**Subject:** Submittal of Replacement Pages to Update the NAC-UMS<sup>®</sup> FSAR from Revision 4 to Revision 5 (Docket No. 72-1015)

**10 CFR 72.48 Evaluation Summary Report**

**NAC-UMS<sup>®</sup> Universal Storage System  
(Docket No. 72-1015)**

<b>NAC INTERNATIONAL</b>		
TRANSPORTABLE STORAGE CANISTER, (TSC) NAC-UMS®		
PROJECT 790	DRAWING 585	REV 19
	2 of 3	3-11-2008

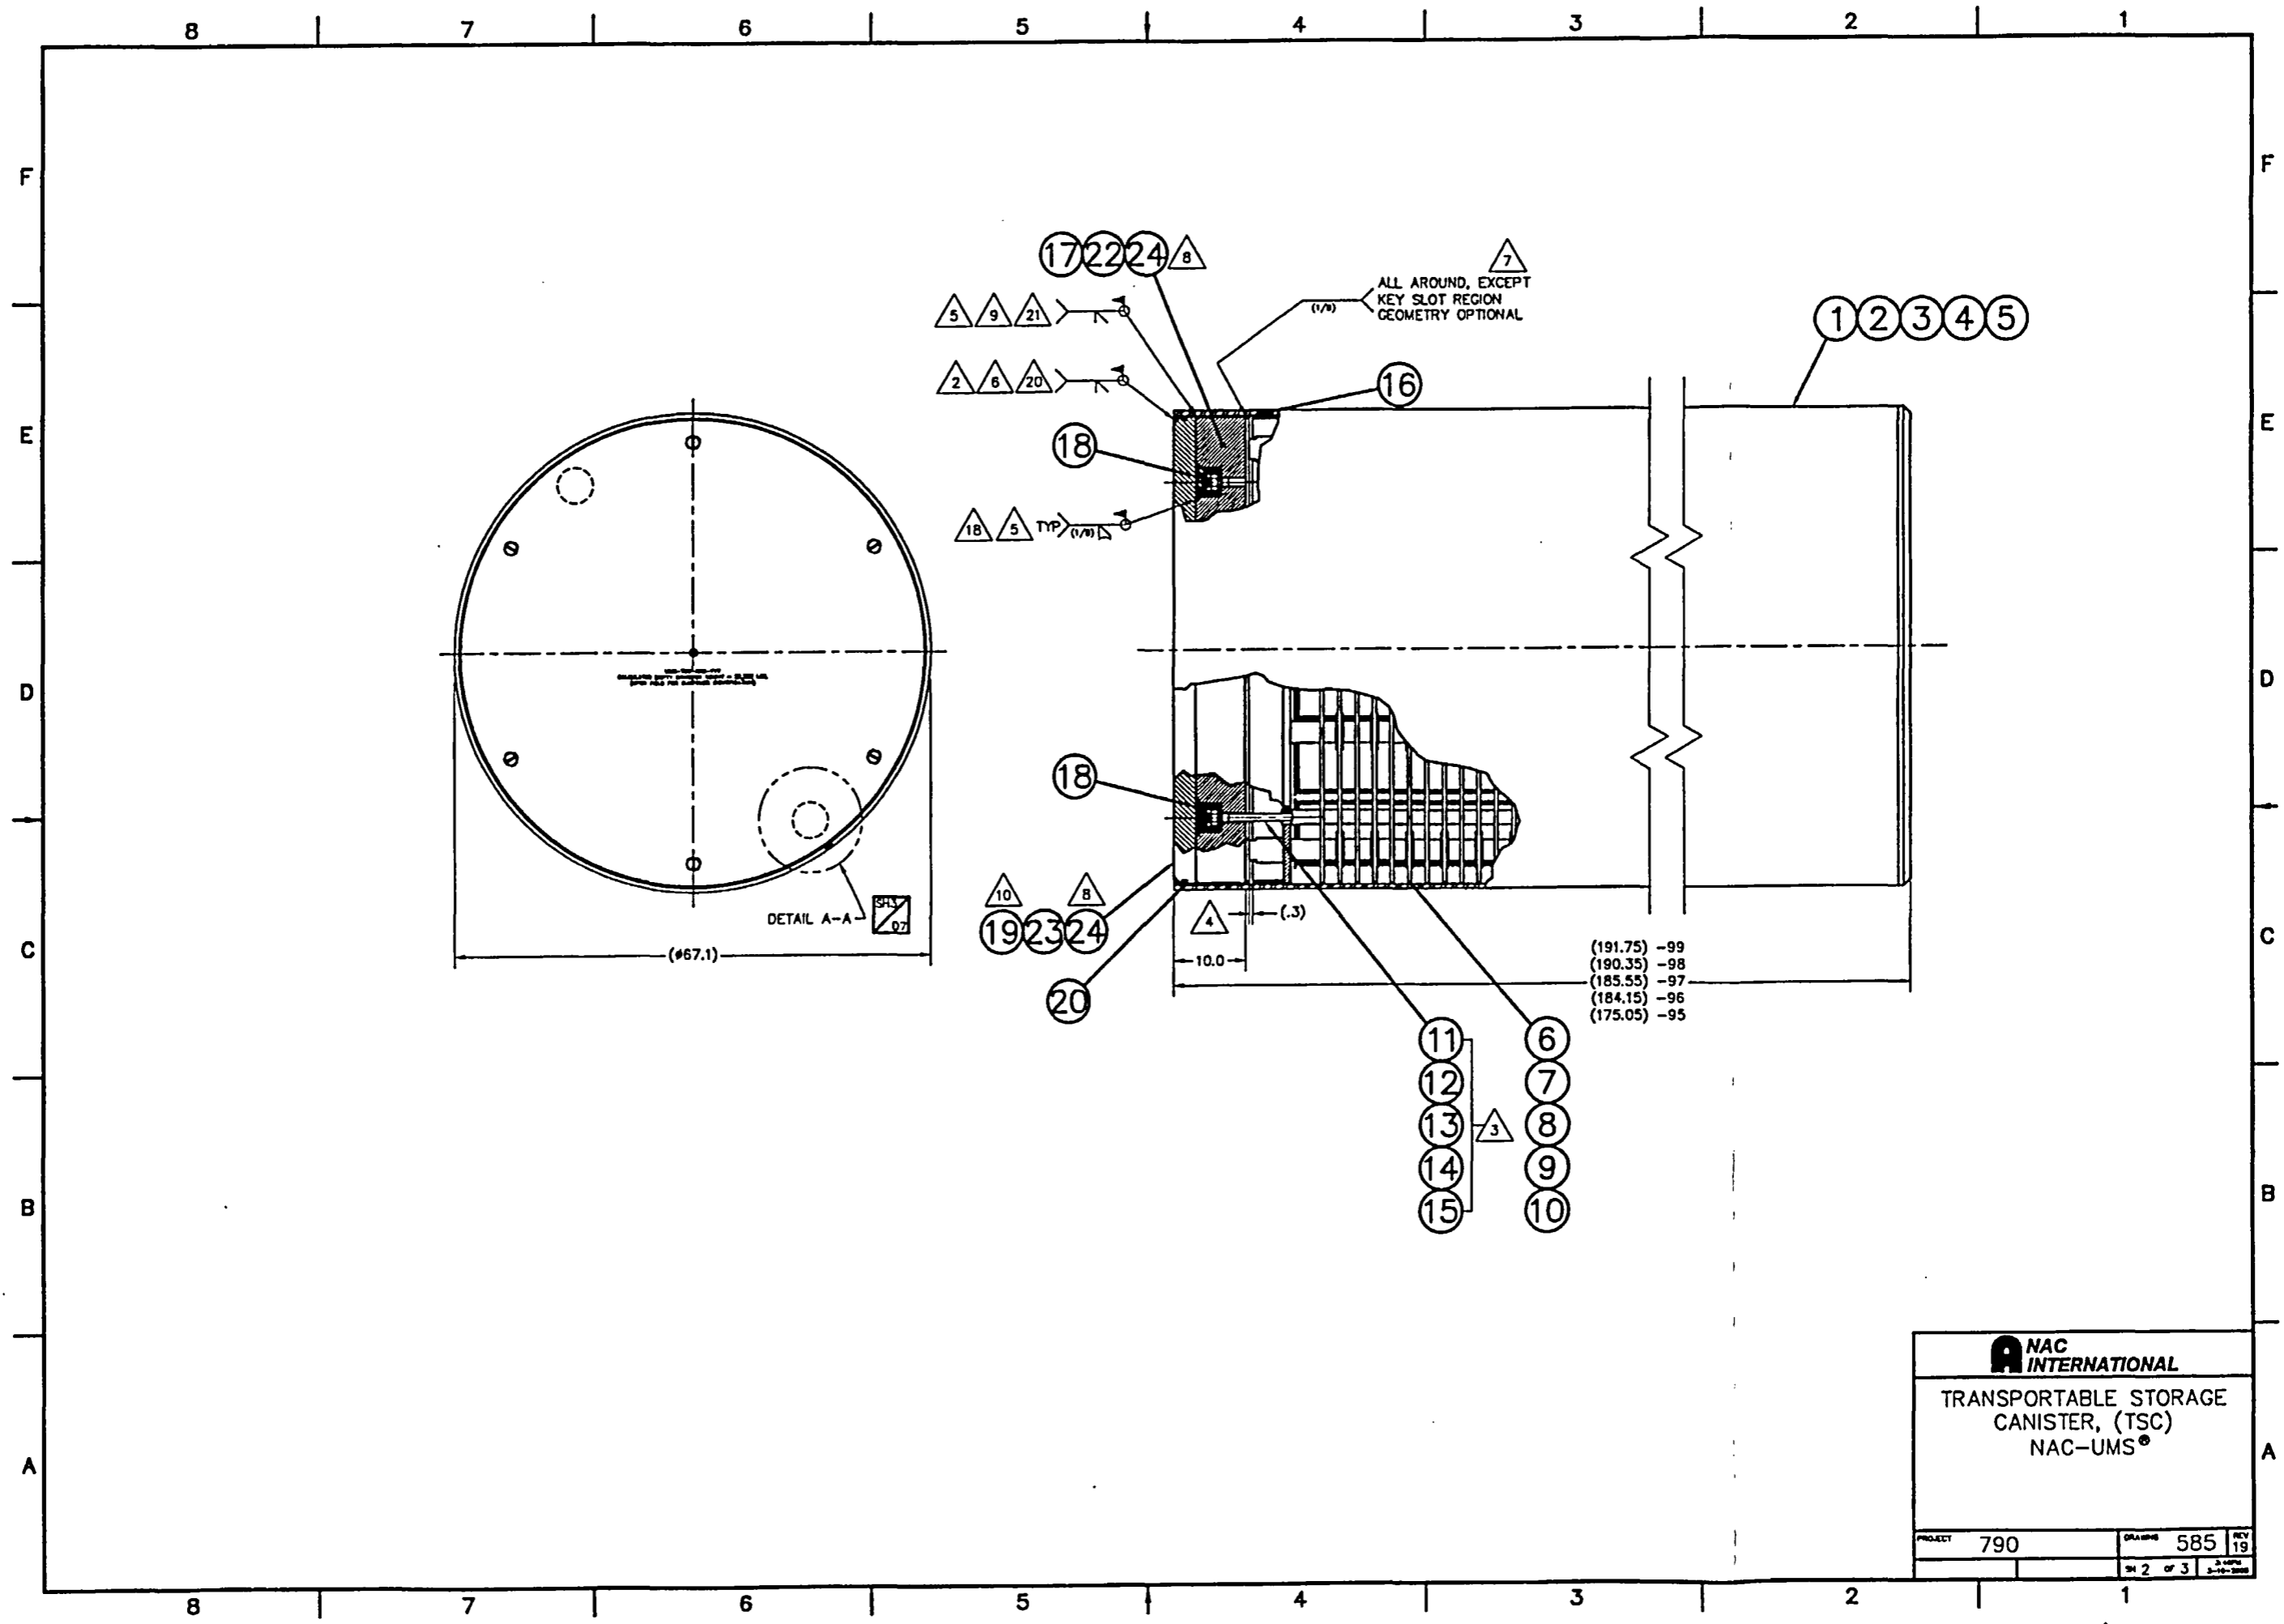
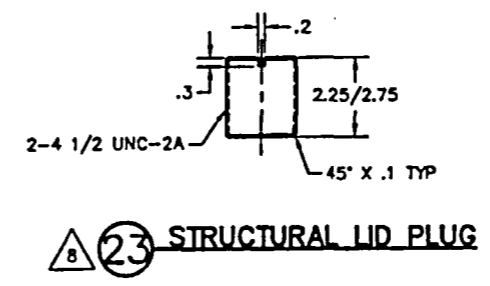
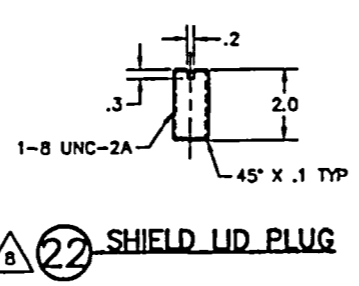
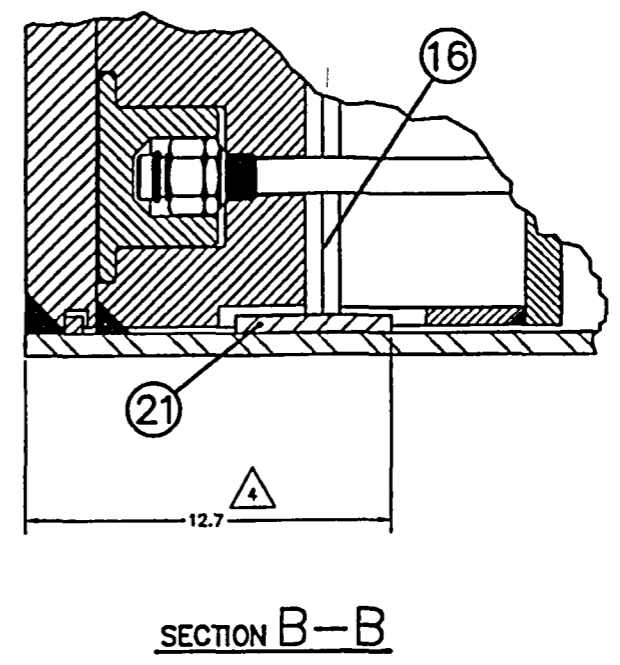
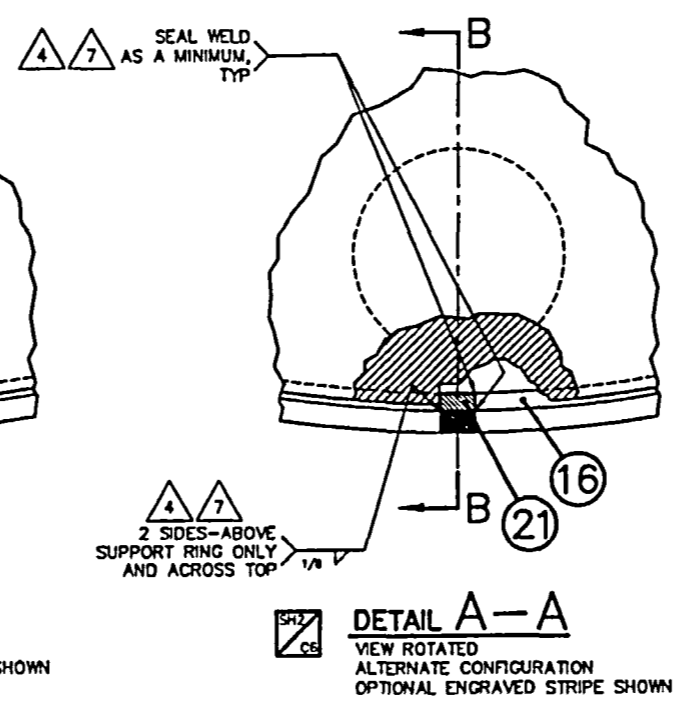
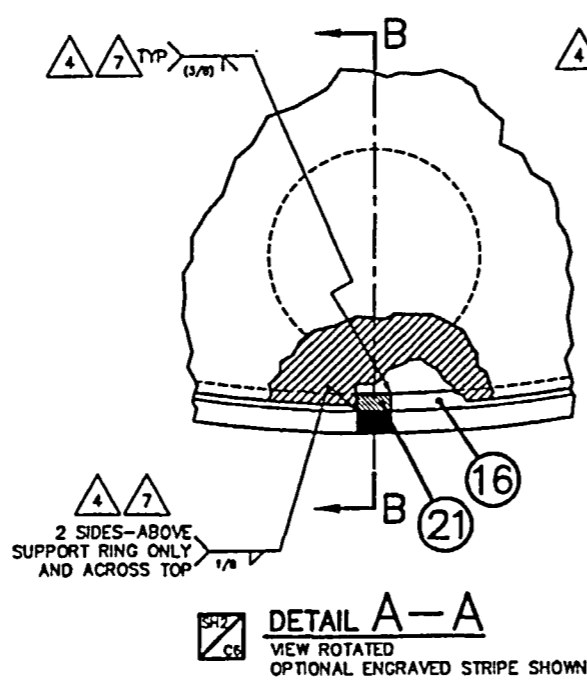
Revision 19 of Drawing 790-585 includes the following changes:

The note change applies to the lid stack-up measurements, prior to installation of the two lids and their closure welding activities. This change has no impact on the performance of each component and/or the overall system functionality. The final structural lid height verification assures the TSC assembly complies with all analyzed condition(s). With this DCR(L), the drawing will bound all final as-built conditions noted in the site documentation packages for the Maine Yankee project.
